Addendum No. 2

OSWWTP Phase 1 Replacement Project

Corolla, Currituck County, North Carolina

June 16, 2015

HEADWORKS MIXERS SUPPORT BEAMS (TYP OF 2)

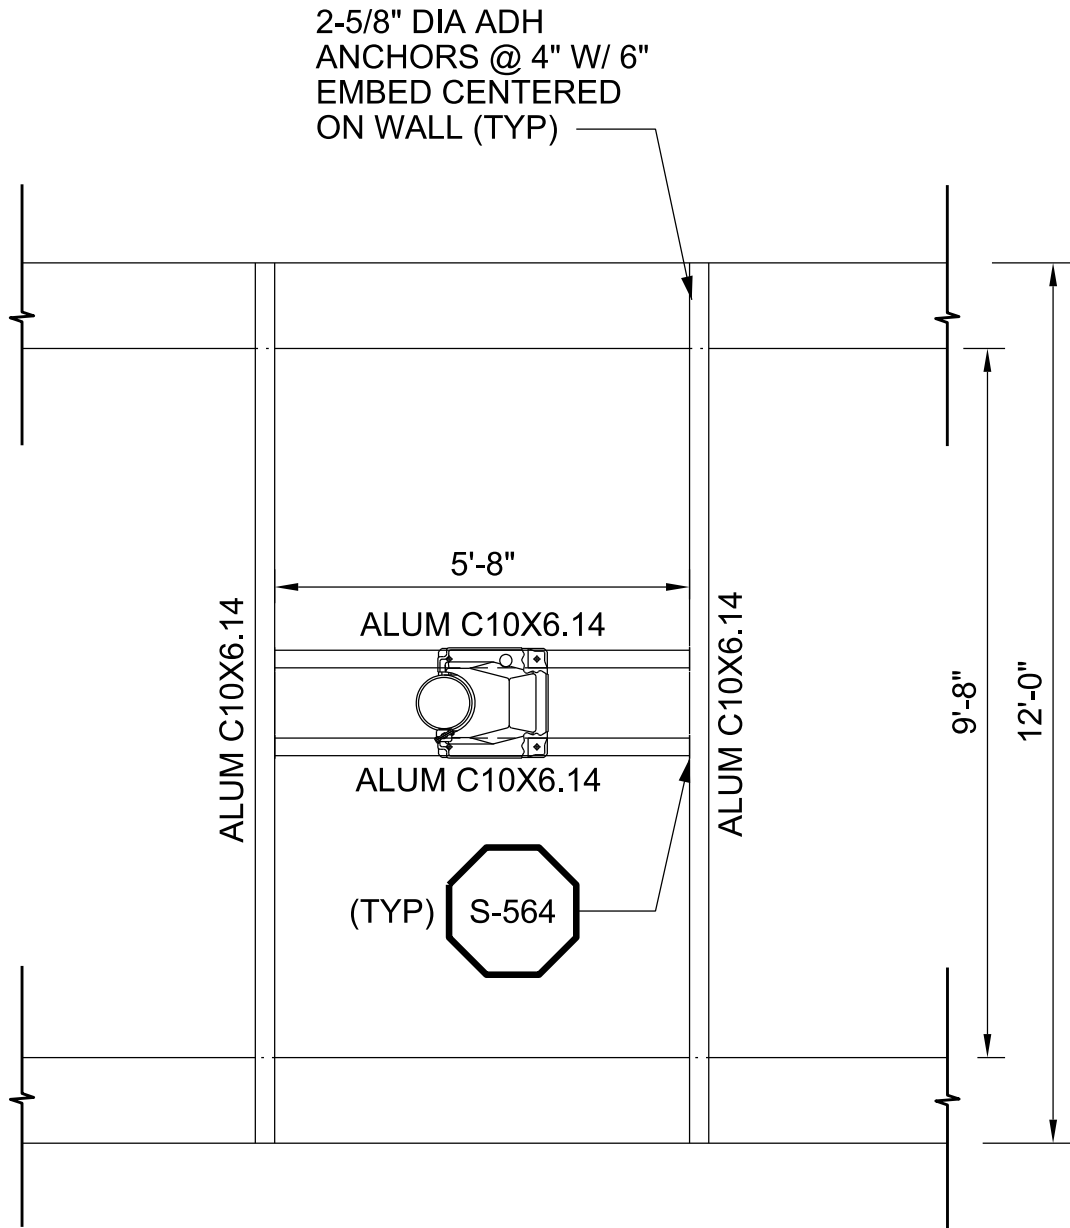
1. If the alum. cover alternate bid is not accepted, how will the mixers be supported?

Please see the attached detail.
